Access Compliance Report

Public Rights-of-Way

(Curb Ramps)

Intersection ID: 32114	Main Street: DUNDALK_RD	Cross Street: WILSON_DR	Location: S
ADA ID: 86351FCBAF6B	Ramp Type: Perp	Initial Pass/Fail: Fail	Overall Compliance: No
Severity Score: 1.25			
Codes/Mitigation Info/Possible Solution		Field Measurements/Component Compliance

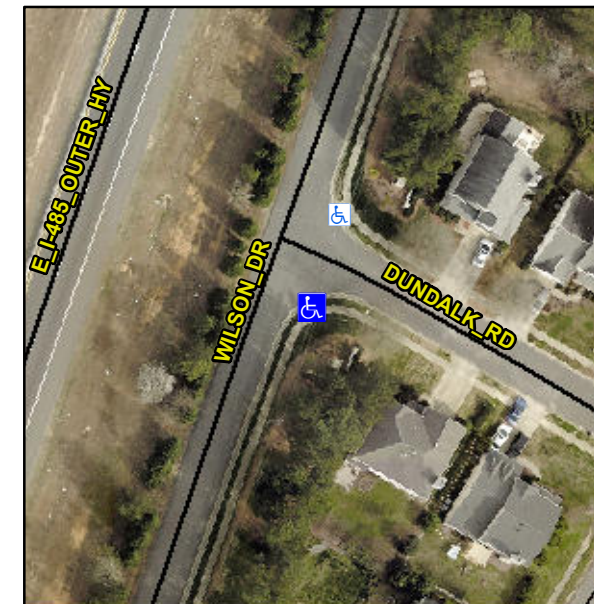
Not Found, R304.5.3

Compliance	Description	Data	Compliance	Description	Data
N/A	Ramp Length (in)	52.5	Yes	Ramp Slope (%)	5.9
Yes	Ramp Width (in)	50.5	No	Ramp XSlope (%)	4.9
N/A	Flare Type LT	N/A	N/A	Flare Type RT	N/A
N/A	Flare Slope LT (%)	N/A	N/A	Flare Slope RT (%)	N/A
N/A	Flare Traversable LT?	N/A	N/A	Flare Traversable RT?	N/A
N/A	Landing Length (in)	N/A	N/A	DWS Provided?	N/A
N/A	Landing Width (in)	N/A	N/A	DWS Contrast?	N/A
N/A	Landing Slope (%)	N/A	N/A	DWS Length (in)	N/A
N/A	Landing X Slope (%)	N/A	N/A	DWS Full Width?	N/A
N/A	Landing Curb? (Y/N)	N/A	N/A	DWS Offset (in)	N/A
N/A	Shared Landing?	N/A			
N/A	Gutter Ponding?	N/A	N/A	Gutter Slope (%)	N/A
N/A	Gutter Lip Ht (in)	N/A	N/A	Gutter X Slope (%)	N/A
N/A	Painted X Walk1?	No	N/A	Painted X Walk2?	N/A
	X Walk 1 Direction	To NE		X Walk 2 Direction	N/A
N/A	X Walk 1 Width (in)	N/A	N/A	X Walk 2 Width (in)	N/A
	X Walk 1 Slope (%)	0.9		X Walk 2 Slope (%)	N/A
	X Walk 1 X Slope (%)	6.1		X Walk 2 X Slope (%)	N/A

Remove & Replace Entire Ramp.
